AMENDMENTS TO THE DRAWINGS:

10/501253

FIG. 1

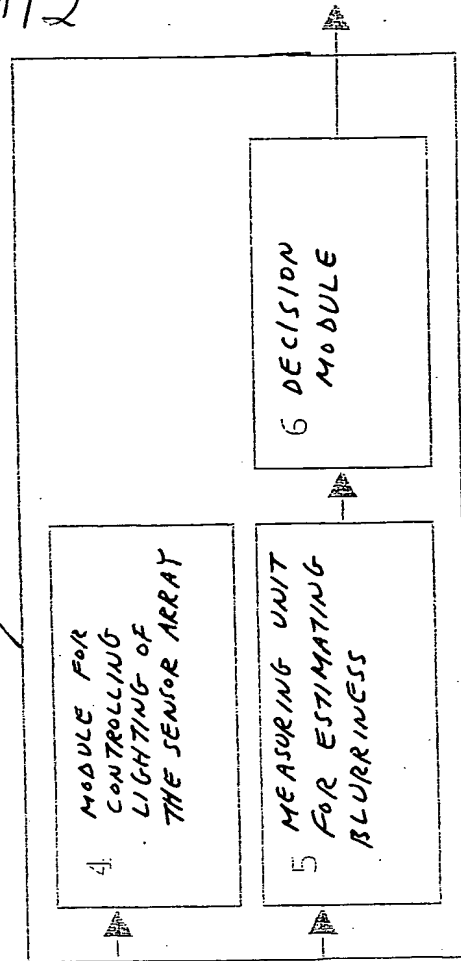
The attached two sheets of drawings include changes to Figs. 1 - 4b. These two sheets, which include Figs. 1 - 4b, replace the original sheets including Figs. 1 - 4b. In Fig. 1, descriptive labels have been added. In Figs. 2a - 4b, axes of graphs have been more clearly labeled.
